Project	IEEE 802.16 Broadband Wireless Access Working Group < http://ieee802.org/16 >	
Title	Enhancement to Space-Time Codes for 3 Transmit antennas for the OFDMA PHY	
Date Submitted	2004-09-01	
Source(s)	<p>Erik Lindskog, Djordje Tujkovic, V. Shashidhar, B. Sundar Rajan, Tareq Al-Naffouri, Erik Stauffer, Taiwen Tang, Bob Lorenz, Babu Mandava, A. Paulraj, K. Giridhar, Kamlesh Rath, Aditya Agrawal</p> <p>Beceem Communications, Inc. Freedom Circle, Suite 101 Santa Clara, CA 95054</p> <p>ChanByoung Chae, Wonil Roh, Hongsil Jeong, JeongTae Oh, Kyunbyoung Ko, SungRyul Yun, Seungjoo Maeng, Panyuh Joo, Jaeho Jeon, Jaeyeol Kim, Soonyoung Yoon</p> <p>Samsung Electronics Co., Ltd. Wen Tong, Peiying Zhu, Jianglei Ma, Ming Jia, Hang Zhang and Mo-Han Fong</p> <p>Nortel Networks 3500 Carling Avenue Ottawa, ON. K2H 8E9 Canada</p>	<p>elindskog@beceem.com</p> <p>Voice: +1-408-387-5021 Fax: +1-408-496-0040</p> <p>cb.chae@samsung.com</p> <p>Voice: +82-31-279-4828</p> <p>wentong@nortelnetworks.com</p> <p>Voice: (613)-763-1315 Fax: (613)-765-7723</p>

Re:	802.16e/D5	
Abstract	Space-time codes for 3 transmit antennas with full diversity.	
Purpose	Modify the 3 transmit antenna space-time codes in 802.16e

Figure 1

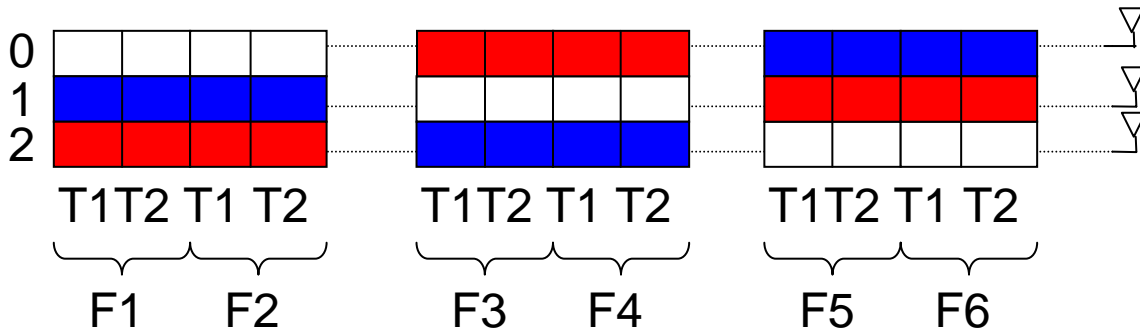
The matrices A_1 to A_3 and the matrices B_1 to B_3 then applied in a cyclic manner as they are deployed on the subcarriers. This is illustrated in Figure 1.

The 3 Tx antenna Matrix A and B in 802.16e/D4 are defined over 2 OFDM symbols and 2 frequencies. This is represented by the left-most rectangle in Figure 1..

In case of Matrix A, the zeros in the row 0 and 2 result in higher power on row 1. Cycling through its permuted versions across 6 frequencies balances the power on each antenna.

In case of Matrix B, the power boost introduced on row 2 by Equation (1) is distributed equally over all antennas by cycling through its permuted versions across 6 frequencies. This again balances the power assigned to each antenna.

Row k ($k = 1, 2, 3$) in Matrix A and Matrix B is mapped to antenna:

$$\text{mod}(\text{logical_data_sub_carrier_number_for_first_tone_of_code} + k, 3)$$

The index, k , of the permuted version of Matrix A and Matrix B to use for a particular deployment is given by:

$$k = \text{mod}(\text{logical_data_sub_carrier_number_for_first_tone_of_code}, 3) + 1$$
